ADDENDUM NO. 3

PROJECT NAME: UNL Devaney Sports Center Improvements
UNL PROJECT NUMBER: C100P098

DATE OF ISSUANCE: Wednesday, April 11, 2012

FINISH QUESTIONS & ANSWERS

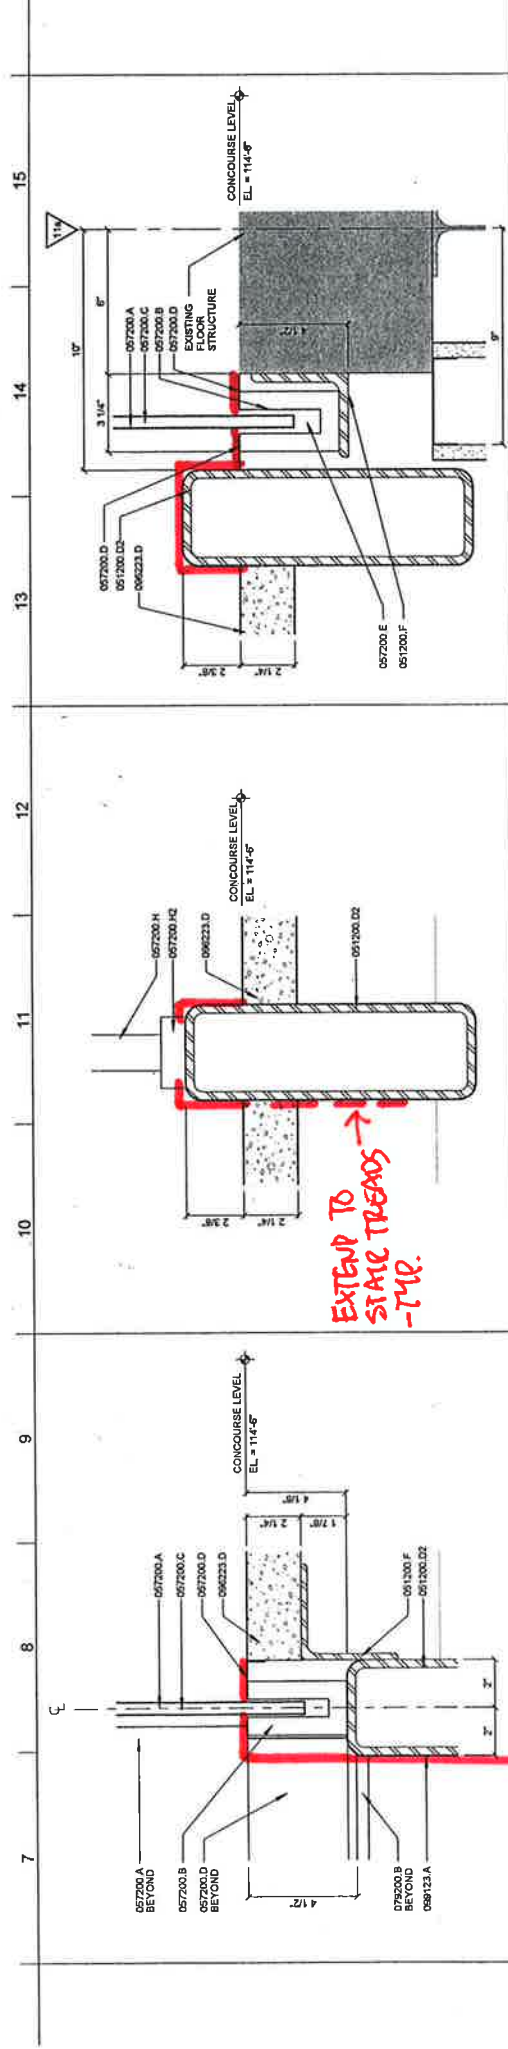
Q: Rooms 332 & 334 RFS = APC-1 RCP = Drywall. Which is right?

A: RCP—GYPSUM BOARD.

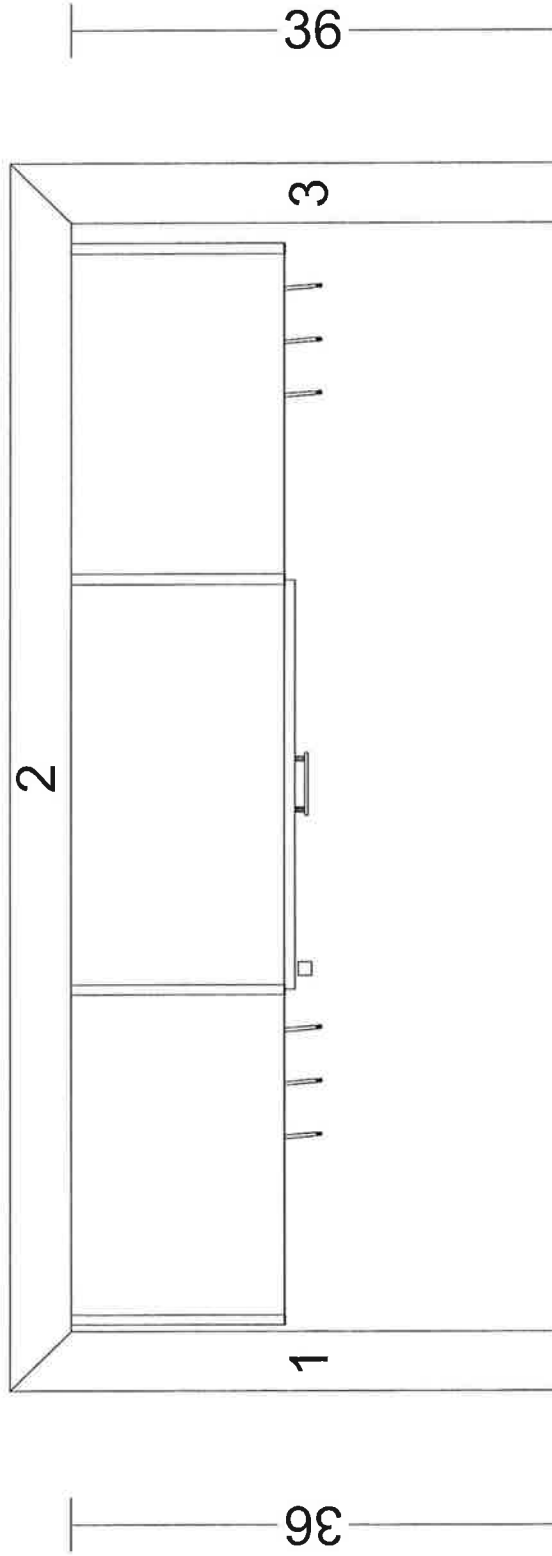
1. Refer to the Details N7, N10, and N13. At the glass and stainless steel rail systems, the stainless steel cladding provided to cover the base shoe extrusion shall be extended to cover the exposed portions of the structural steel stringers. (See the attached sketches indicating the extent of the stainless steel cladding).

← EXTEND TO BOTTOM OF EXPOSED STRINGER - TYP.

EXTEND TO STATIC TRENDS - TYP.

BASKETBALL COACH'S CLOSET

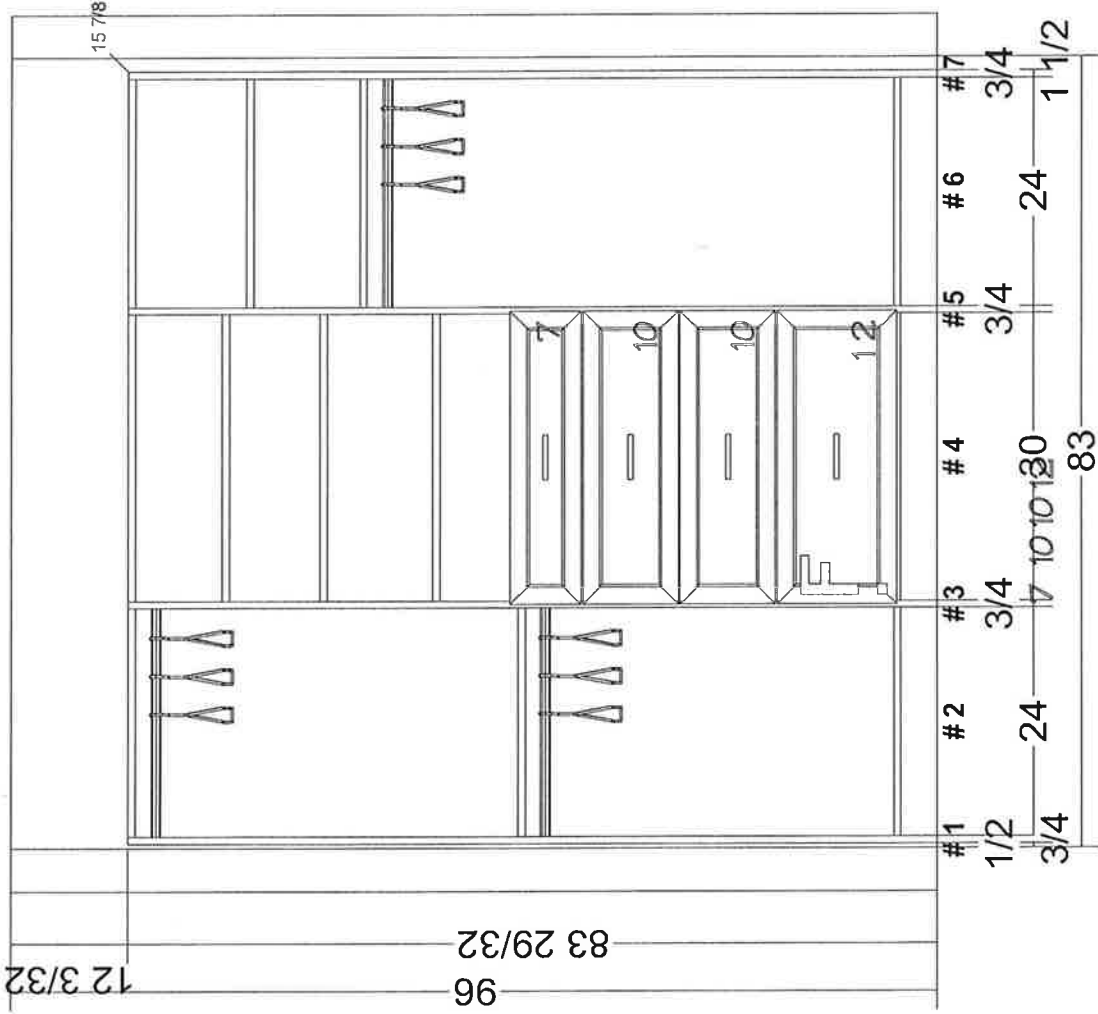
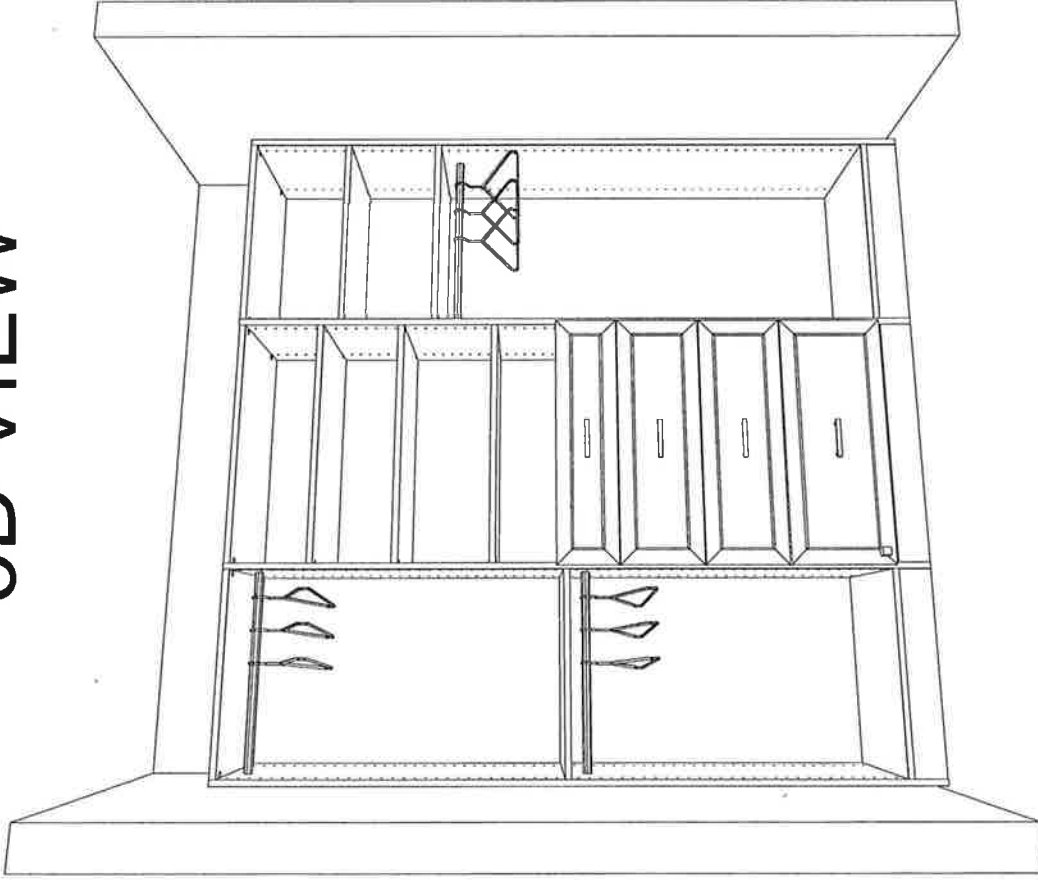
1. Refer to Elevation H11. The closet millwork in this elevation, is not as specified in Section 064023. This millwork is a custom closet organizing system—similar to that provided at the Hendricks Addition. The material for this system is to be Clear Maple with a stained finish as selected by the Owner. (See the attached Submittal drawing from the Hendricks project indicating the intent of this installation.)
2. Refer to Elevation L1. The north wall is to receive a wood wainscot in the sections of wall shown as paint only. The wainscot is to be 3'-8" tall to match the top of the backsplash at the east wall casework.

11 DETAIL @ "N" DOOR PULL
2

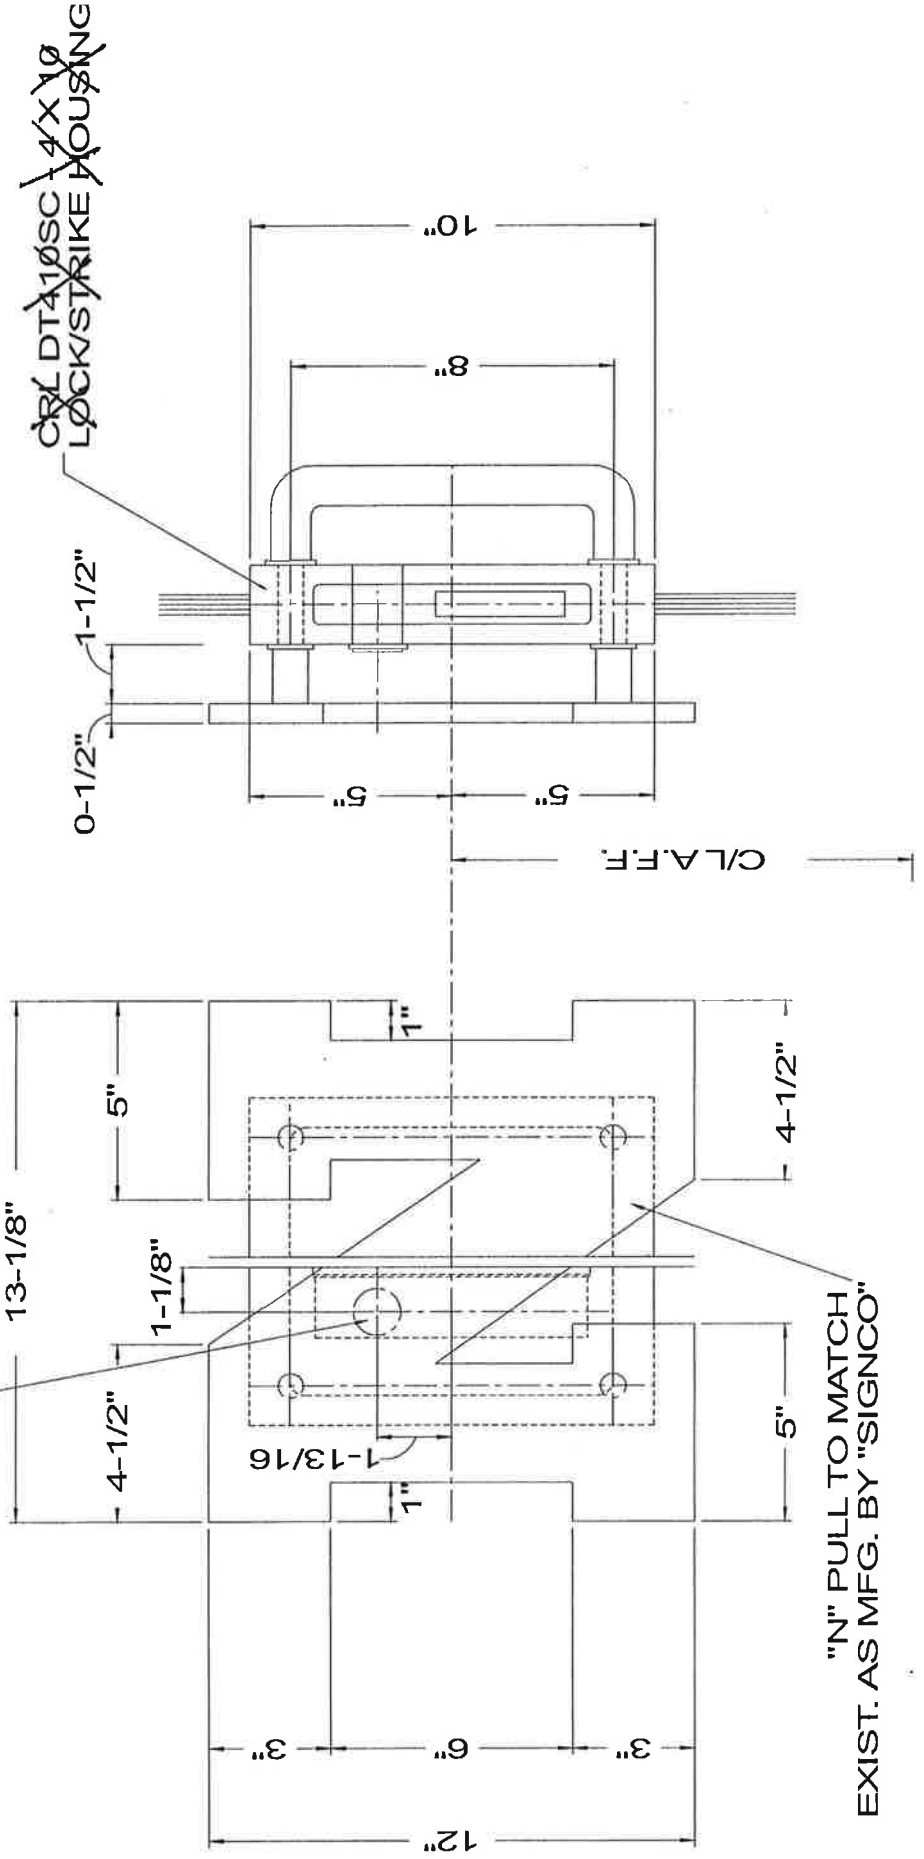
~~Install Lock Set So Cylinder Is Above Custom "N" Door Pull. Do Not Provide Hole In Pulls.~~

~~ARCHITECT TO PROVIDE HOLE SIZE IN PULL FOR KEY ACCESS TO LOCK~~

"N" PULL TO MATCH EXIST. AS MFG. BY "SIGNCO"

DEVANEY SPORTS CENTER
 POOL LEVEL PLAN -
 MECHANICAL

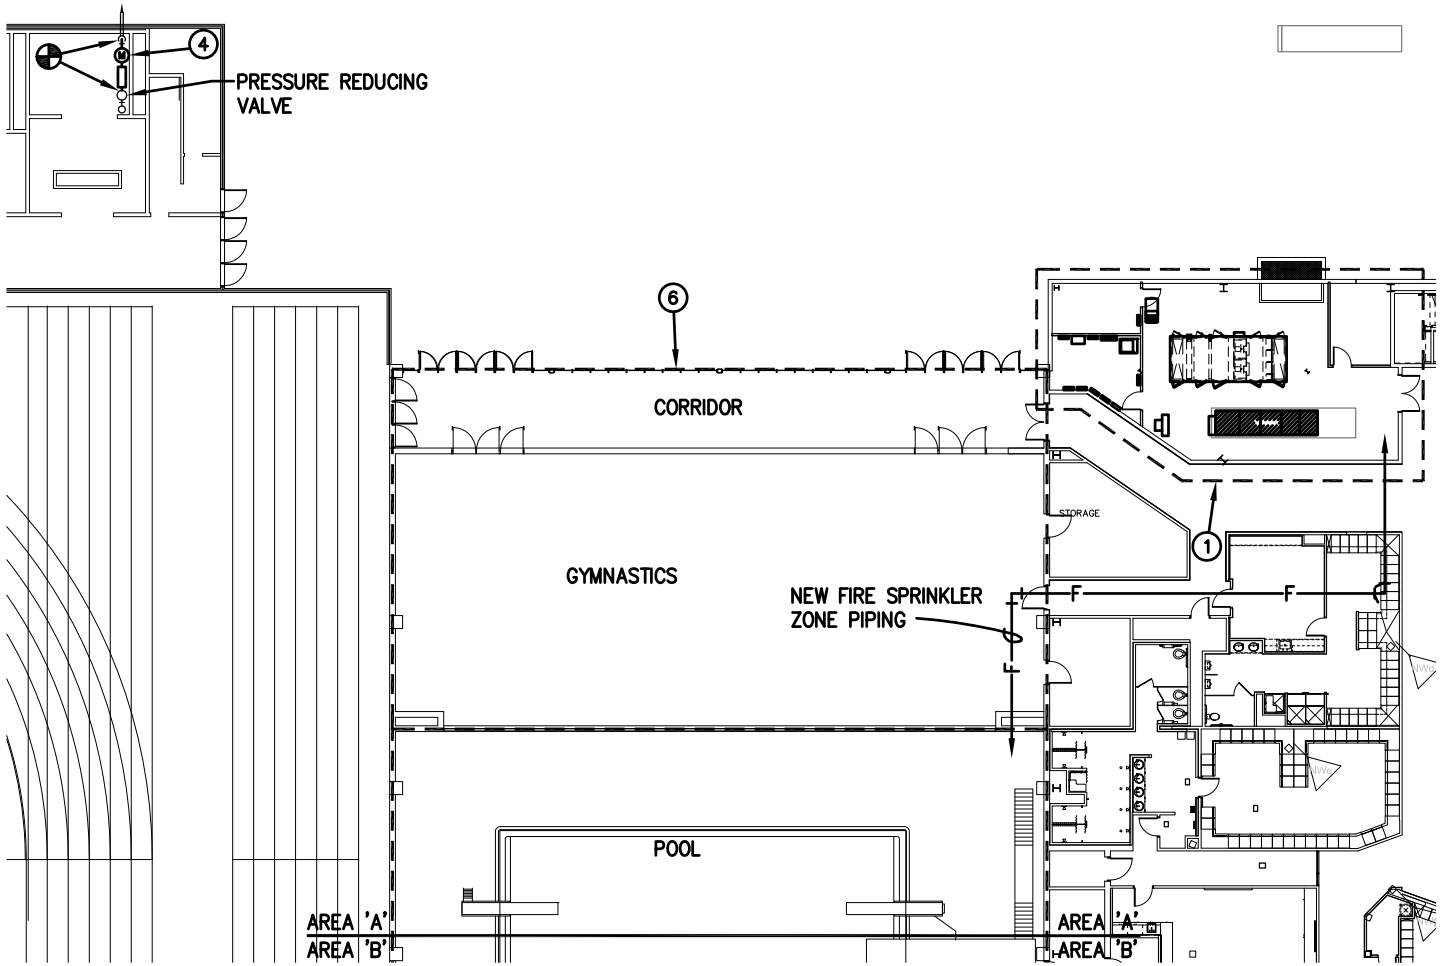
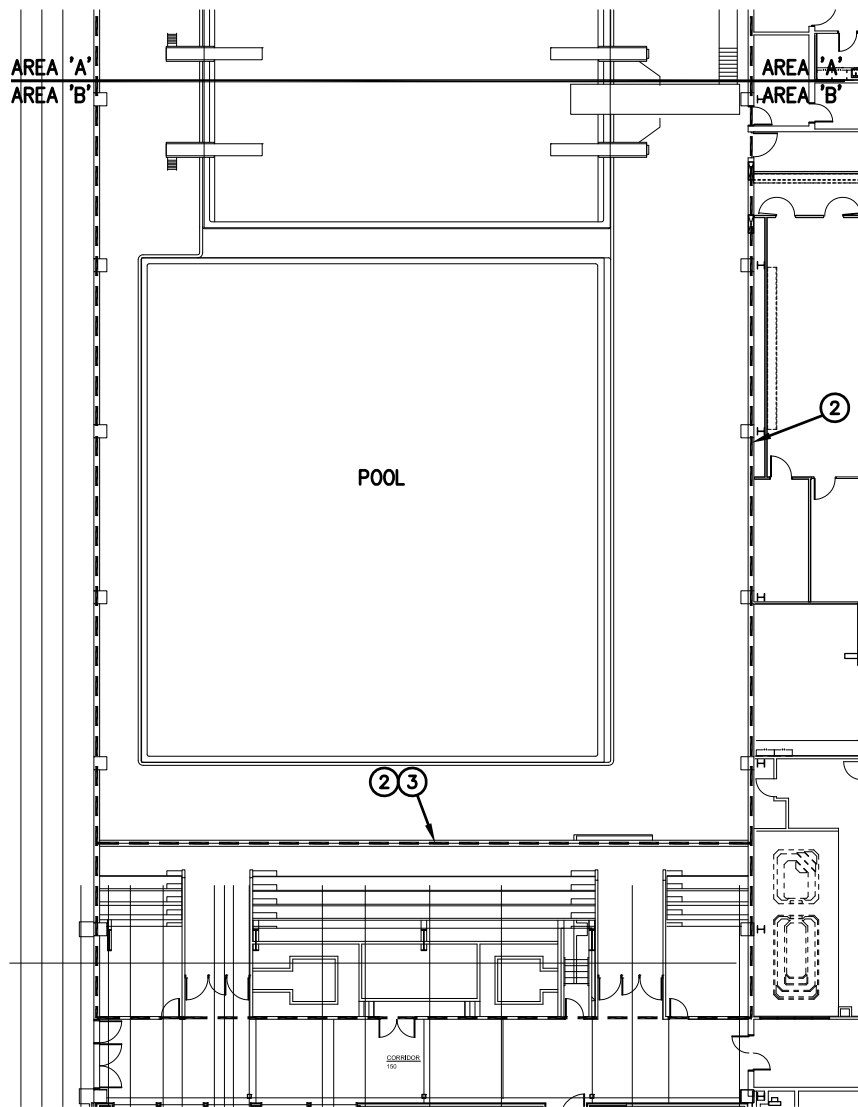
- 1. Sheet M204 – Pool Level Plan – Mechanical
 - A. This sheet was inadvertently left out. See attachments 1M, 2M, 3M, and 4M for further detail.

DOMESTIC WATER METER/ BACKFLOW PREVENTER DETAIL

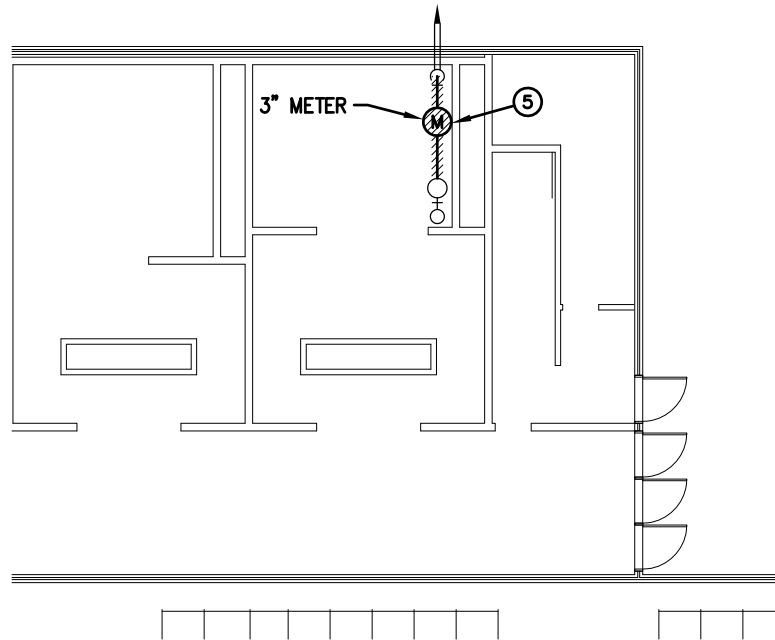
1. WATER SERVICE IN NORTHWEST MECHANICAL ROOM 138 IS A 6" SERVICE.
2. WATER SERVICE IN THE TRACK AREA IS A 4" SERVICE.
